July 29, 2020

ADDENDUM NO. 2
TO CONTRACT DOCUMENTS FOR THE
PACHECO PUMPING PLANT PRIORITY 1 FIRE ALARM
AND SUPPRESSION SYSTEM IMPROVEMENTS PROJECT
Project No. 91214010 Contract No. C0653

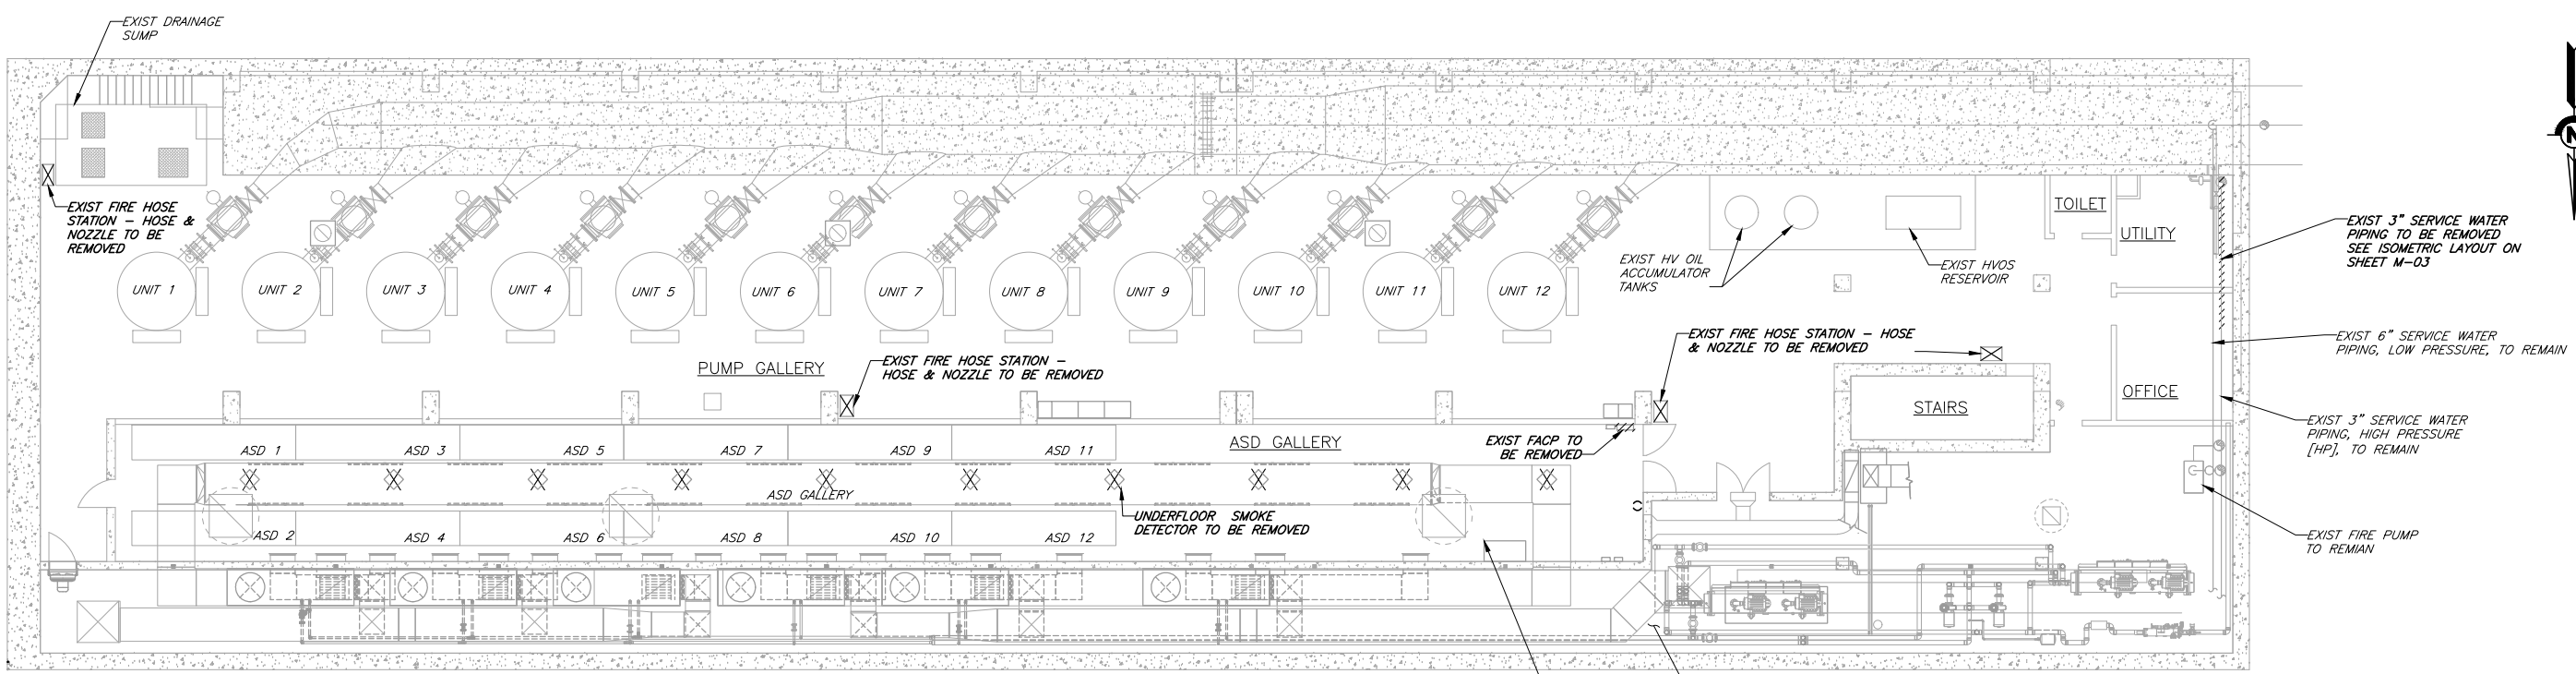
5. **QUESTION.** Spec 12.01 - B.1. Regarding demo of existing fire control, please provide drawings that show the extent of the demolition work.

RESPONSE. See **Addendum #2, Item 28**, Sheet D-01, and below.

Demolition on this project is composed of the following:

- 1) Removal of the existing FACP
- 2) Removal of a small section of water pipe associated with the Fire Water supply.
- 3) Removal of the existing underfloor smoke detectors, junction boxes, and conduit branches
